**ADDENDUM NO. 1  
TO  
BRO-B048 (052)  
BRIDGE NO. 2125030  
CITY OF INDEPENDENCE,  
JACKSON COUNTY, MISSOURI**

February 1, 2013

**BLY ROAD/BRRIDGE IMPROVEMENTS**

City Project No. 70110802

PLAN & PROFILE - SHEET 3 OF 3

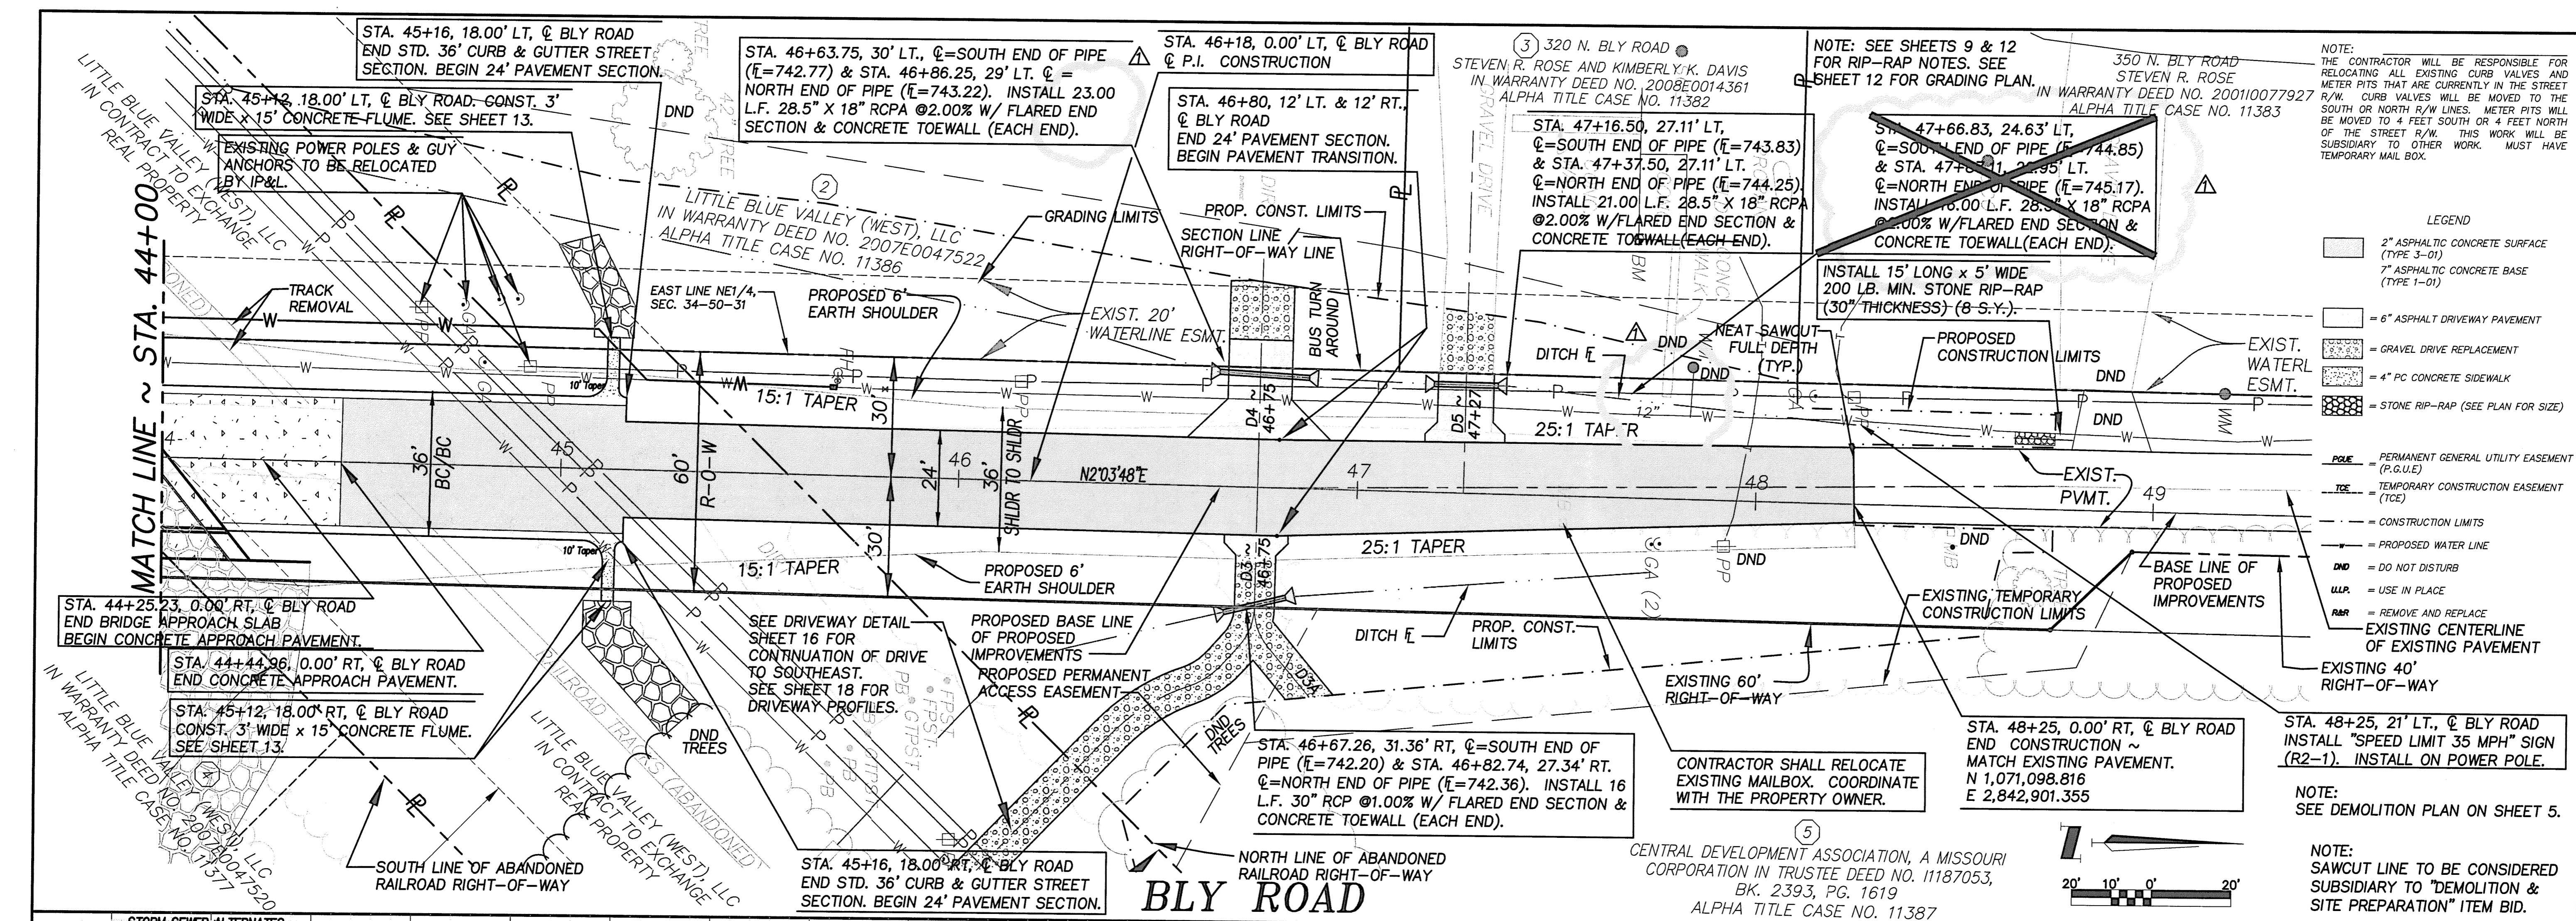
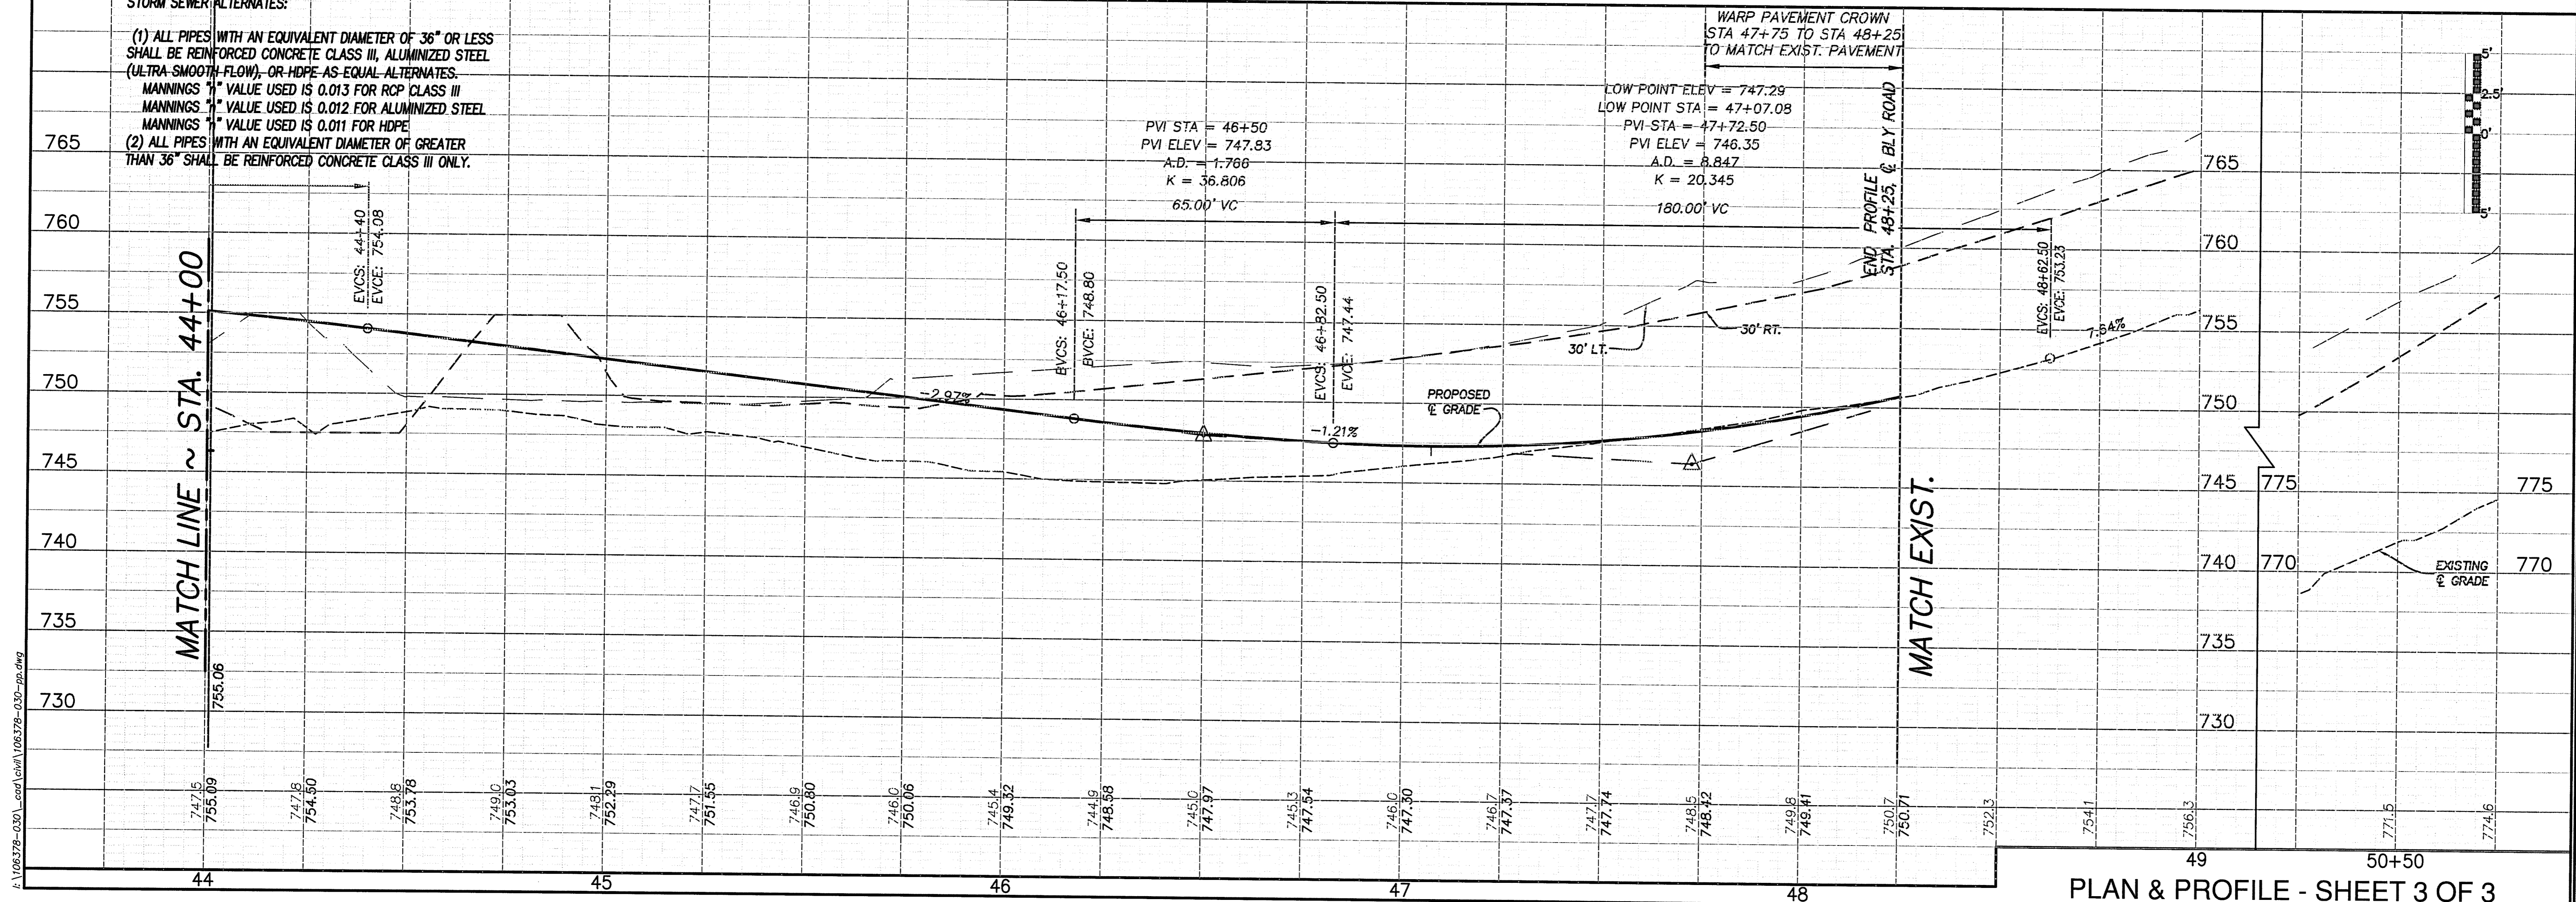
- 1) Sheet 8 of 50, Plan & Profile – Sheet 3 of 3, *16 L.F. of 28.5"x18" RCPA Storm Sewer Pipe, Flared End Sections and concrete sidewalk at STA. 47+66.83 will not be constructed. RCPA Storm Sewer Pipe at STA. 46+63.75 quantity revised to 23 L.F.*
